Access Compliance Report Public Rights-of-Way (Curb Ramps)

Main Street: CEDARWOOD_AVE Cross Street: DARWIN_AVE Location: NE

ADA ID: RPRK211005175536 Ramp Type: Type 1 - Perpendicular Diagonal Initial Pass/Fail: Fail Overall Compliance: No Severity Score: 16

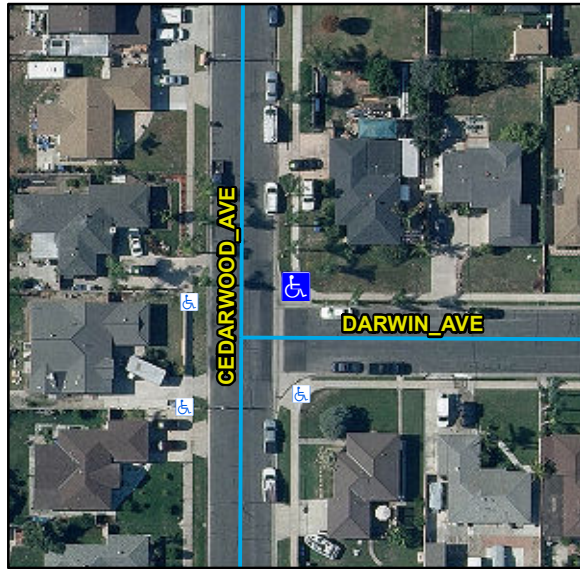
Compliance	Description	Data	Compliance	Description	Data
N/A	Ramp Length (in)	92	N/A	Flare Type LT	
Yes	Ramp Width (in)	48			N/A
No	Ramp Run Slope (%)	10.7	N/A	Flare Slope LT (%)	N/A
No	Ramp Cross Slope (%)	2.5	N/A	Flare Traversable LT	N/A
N/A	Landing Present	N/A	N/A	Flare Type RT	
N/A	Landing Length (in)	N/A			N/A
N/A	Landing Width (in)	N/A	N/A	Flare Slope RT (%)	N/A
N/A	Landing Run Slope (%)	N/A	N/A	Flare Traversable RT	N/A
N/A	Landing Cross Slope (%)	N/A	N/A	DWS Provided	N/A
N/A	Landing Movement Obstructed?	N/A	N/A	DWS Contrast	N/A
	Landing Movement Type	N/A	N/A	DWS Length (in)	N/A
N/A	Landing Shared	N/A	N/A	DWS Full Width	N/A
N/A	Clear Space	Yes	N/A	DWS Offset Left (in)	N/A
N/A	Clear Space To Crosswalk (in)	N/A	N/A	DWS Offset Right (in)	N/A
N/A	Marked Crosswalk 1	No	N/A	Marked Crosswalk 2	No
	Crossing 1 Direction	W		Crossing 2 Direction	S
	Marked Crosswalk 1 Width (in)	N/A		Marked Crosswalk 2 Width (in)	N/A

N/A	Ramp Inside Crosswalk 1	N/A	Yes	Ramp Inside Crosswalk 2	N/A
	Crossing 1 Slope (%)	9.4		Crossing 2 Slope (%)	0.6
	Crossing 1 Cross Slope (%)	3.4		Crossing 2 Cross Slope (%)	0.1
N/A	Gutter Ponding	N/A	No	Curb Slope	12.4
Yes	Gutter Lip Height (in)	0		Road Run Slope (%)	1.9
N/A	Gutter Run Slope (%)	N/A		Road Cross Slope (%)	9.3
N/A	Gutter Cross Slope (%)	N/A			
Yes	Overall Surface Condition: Acceptable		Yes	Perp Joint Present	Yes
	Cross Gutter Present?	Yes		Spandrel Present?	Yes
	Replace Cross Gutter?	No		Replace Spandrel?	No

Remove & Replace Curb Ramp With Two New Directional Ramps or Equivalent.

R304.2.2, R304.5.3, STD 1115
